609 E. Liberty Avenue
Certificate of Appropriateness HP25-010

Request: This project will replace the existing three car garage with a new three car garage and an upstairs accessory dwelling unit (ADU).

Date of Review: May 20, 2025

Roofing: Steel panel, 29"x120" with "Midnight black" finish.

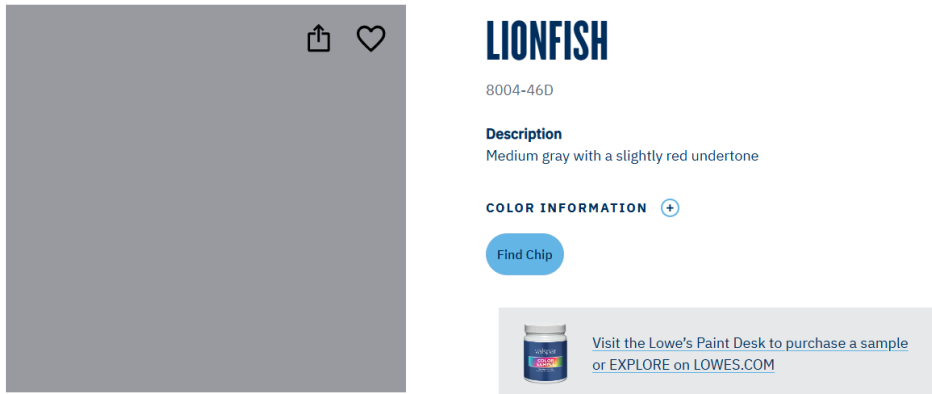
Roofing: Metal roofs and black roofs are not uncommon in the neighborhood; the roof of the historic structure on this lot is black composition shingle. Although the HPC has not approved prefinished metal roofing before, it may be considered here since this is new construction on a secondary building.

- The metal panel roof is an appropriate roofing material. Regarding the finish, the HPC has not previously approved prefinished metal roofs. However, staff believes that the HPC may consider the black prefinished product for a new construction garage.

EXTERIOR ELEVATIONS

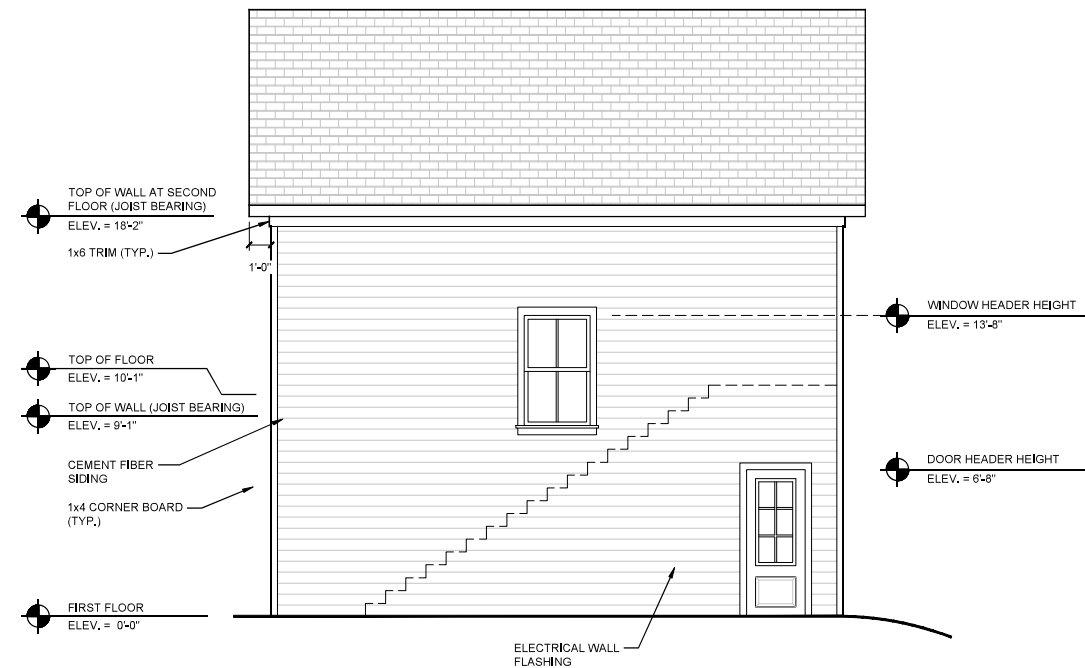
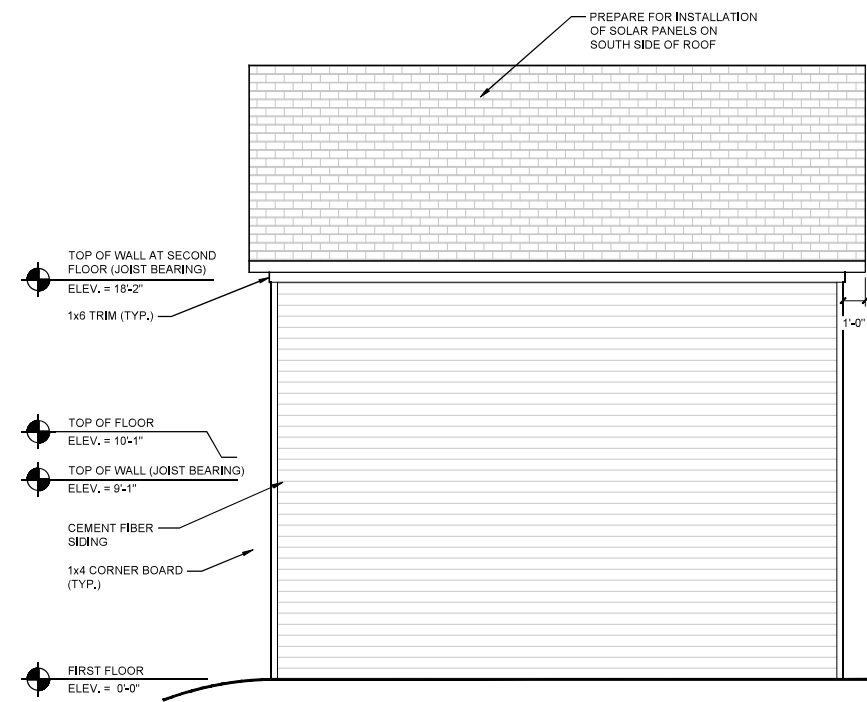
Roof shape: The asymmetric roof shape is unlike the traditional structures in the area. Directing the ridge across the short dimension with the gable facing the street makes the roof taller than otherwise necessary. Staff believes that a more conventional hipped or gabled roof would be more compatible with the neighborhood. Running the ridge in the longer dimension would also place the eave on the street side, which would also help to de-emphasize the building's height.

Staff conveyed the recommendation to change the roof shape, and he responded that his clients would like to keep the roof as it is for how it shapes the interior space. Plans appear to show flat 9 ft ceilings throughout the unit, which would not necessitate the asymmetric roof shape.

- The roof illustrated in the plans has a non-traditional shape that contrasts with the historic structures in the neighborhood. Each slope of the roof has a different pitch, and the ridge is perpendicular to the length of the building rather than parallel. Staff suggests a symmetrically-pitched gable or hipped roof with the ridge parallel to the length of the building. This should also help meet the maximum height of 25 ft allowed by zoning.

- The roof shape presented is not appropriate and must be redesigned in a hipped or gabled form with the ridge running lengthwise. Revised plans must be resubmitted to preservation staff for review.
